Re: Semi-Annual and Annual Report Uranerz Energy Corporation Nichols Ranch ISR Project SUA-1597

**Nichols Ranch ISR Project**  
**License Number SUA-1597**  
**Docket No.40-9067**

**Semi-Annual Report**

INDEX SHEET FOR MINE PERMIT AMENDMENTS OR REVISIONS

PROJECT NO.	CADD	CHECKED BY	APPROVED BY	PLOT DATE	SHEET
1246-001	BJCM	EB	-	11/13/2013 11:15 AM	
NICHOLS RANCH ISR PROJECT					
FIG. 3-3					
NICHOLS RANCH PROCESS FLOW DIAGRAM

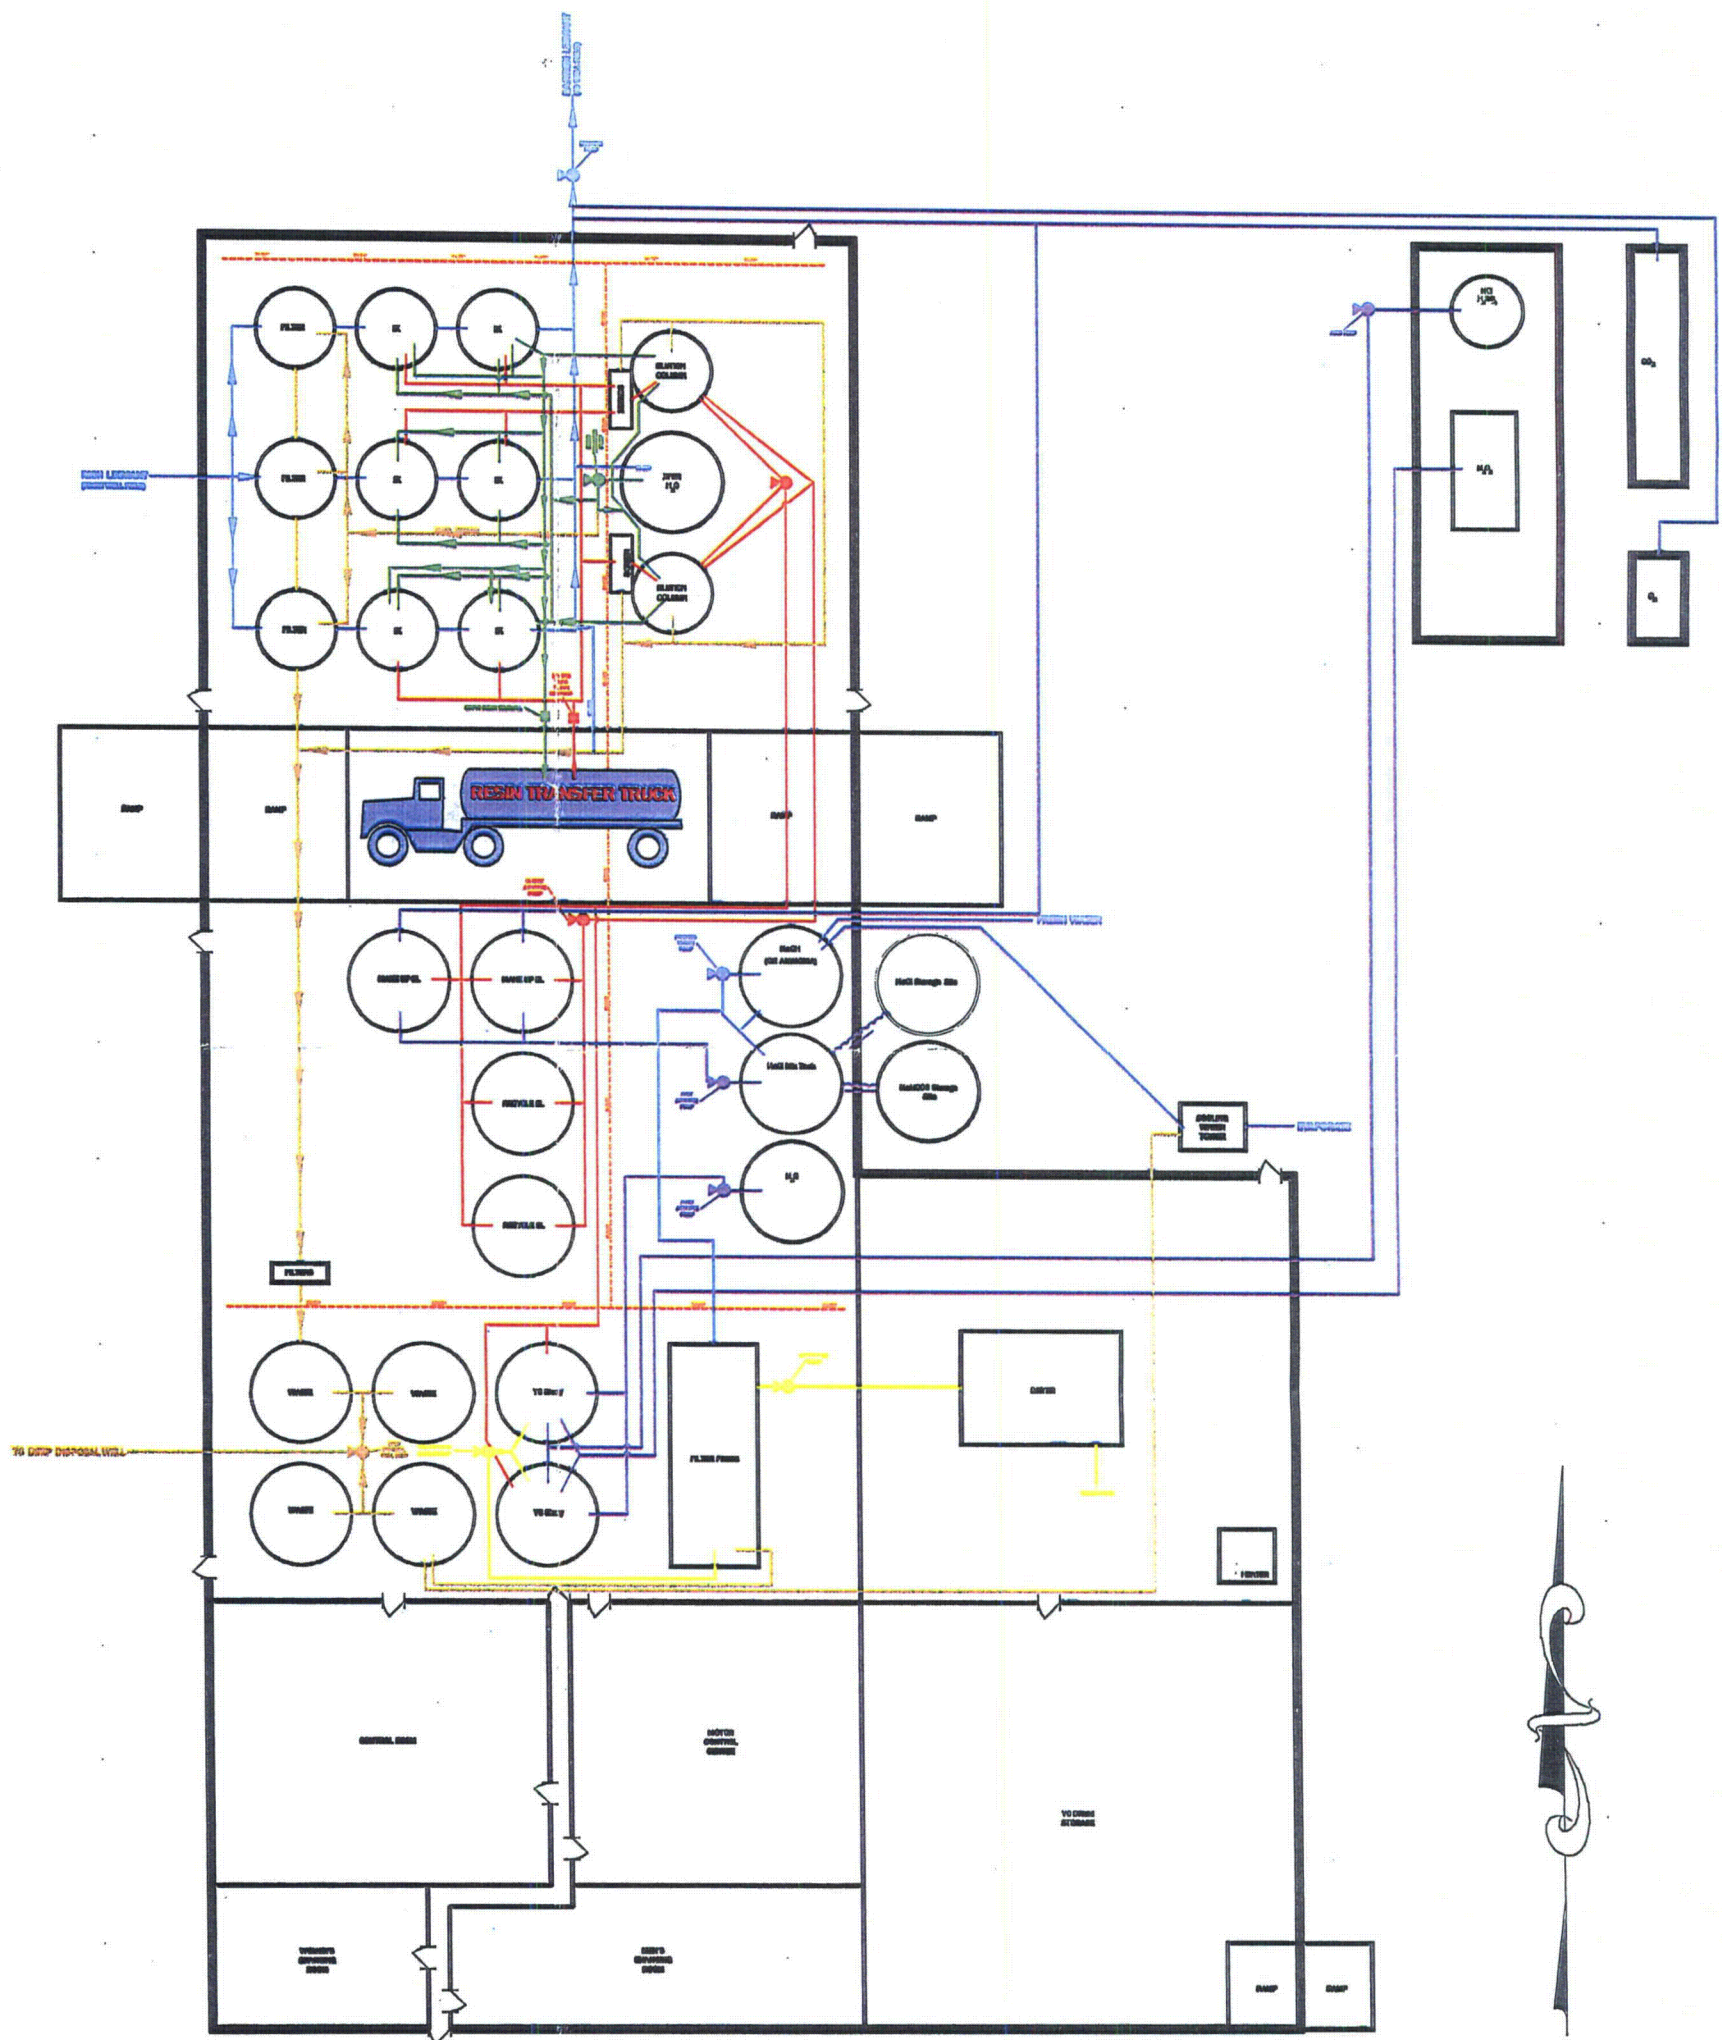
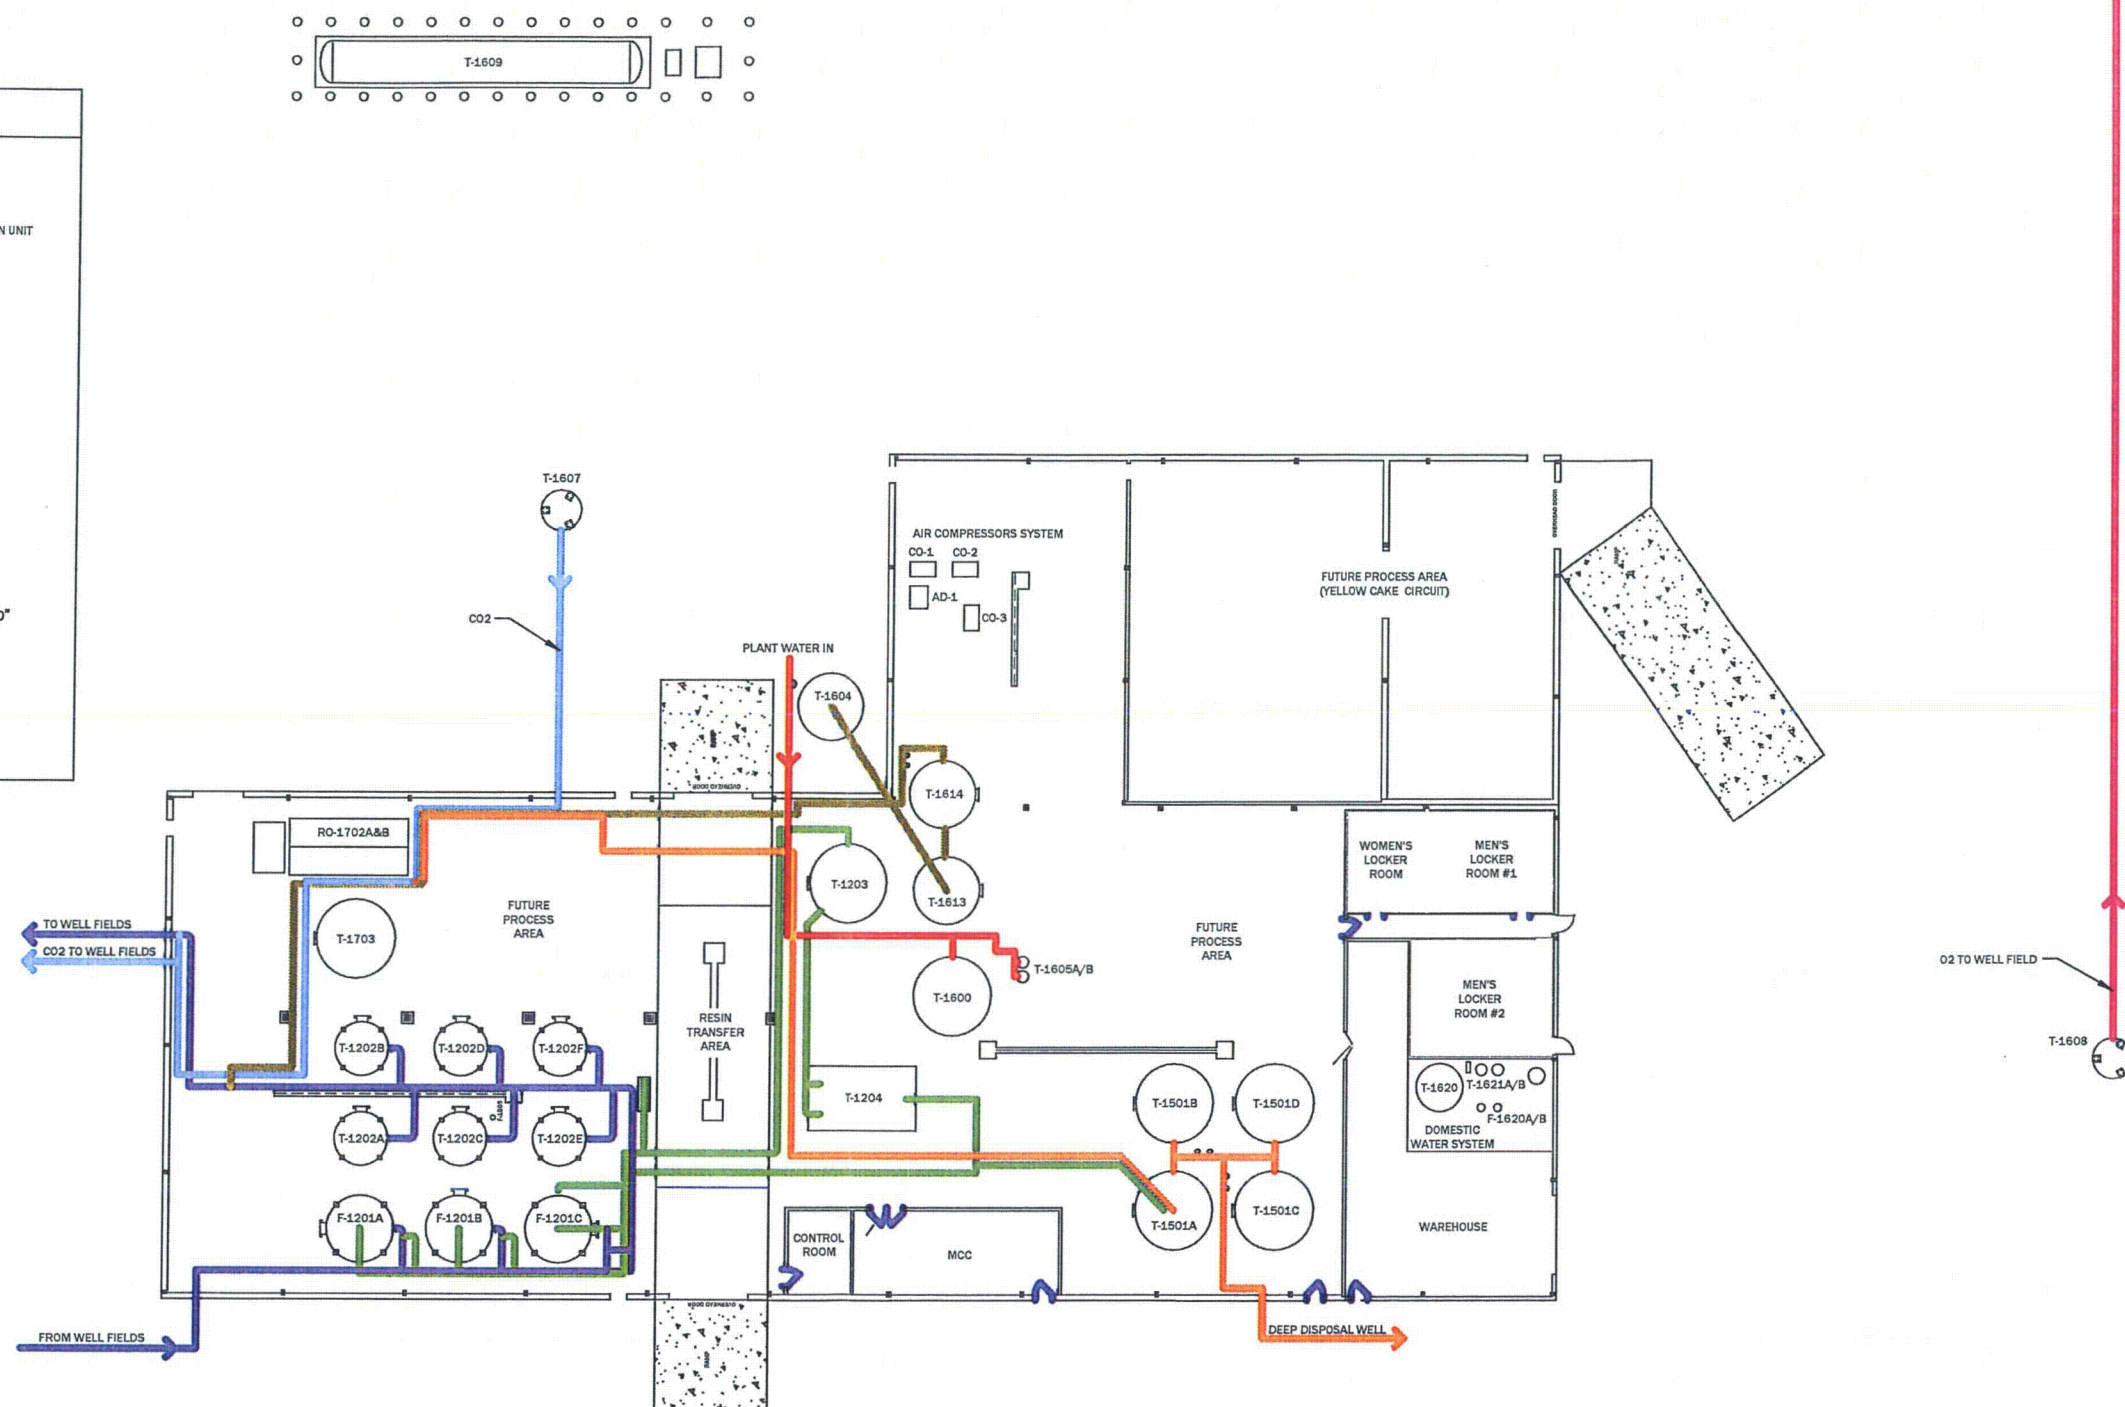
SERP-8-2013	11/12/2013	Plant Design Figure Changes	The SERP evaluated various changes to Figure 3-3 of Section 3 Volume I of the license application. There are six changes that would impact Figure 3-3. These changes evolved during construction and involved revising locations of various rooms and equipment. Two changes involved new equipment not shown on Figure 3-3. Based on the evaluation of the items the SERP concluded that Figure 3-3 of the license application requires revision and will be submitted in the second semi-annual report.

Volume I	Mine Plan Section 5.7.8.10.2, Pg. TR-247 (Rev. Feb. 2009)	Mine Plan Section 5.7.8.10.2, Pg. TR-247 (Revised December 2013)	Page revised for Section 5.7.8.10.2 Water Quality Sampling and Analysis Procedures.
Volume I	Mine Plan Section 7.5.1.2, Pg. TR-313 (Rev.Feb.2009)	Mine Plan Section 7.5.1.2, Pg. TR-313 (Revision August 2013)	Page revised for Section 7.5.1.2 Shipments of Loaded Resin
Volume I	Mine Plan Section 7.5.3.Pg TR-318 (Revised July 2010)	Mine Plan Section 7.5.3.Pg TR-318 (Revised October 2013)	Page revised for Section 7.5.3.1 Process Pipelines.
Volume I	Mine Plan Section 7.5.4, Pg. TR-320 (November 2007)	Mine Plan Section 7.5.4, Pg. TR-320 (Revised July 2013)	Page revised for Section 7.5.4 Fires and Explosions
Volume I	Mine Plan Section 3.0 , Figure 3-3 (Date: October 18, 2007), Figure 3-3a (2/23/2008), Figure 3-13 ( Sept. 25,2007), Figure 3-14 (Sept.25,2007),	Mine Plan Section 3.0 , Figure 3-3 (11/13/2013), Figure 3-13 (7/11/13), Figure 3-14 (7/11/13)	Figures 3-3, 3-13, and 3-14 have been updated and require replacement. Figure 3-3a is being removed as the contents were incorporated into Figure 3-3.
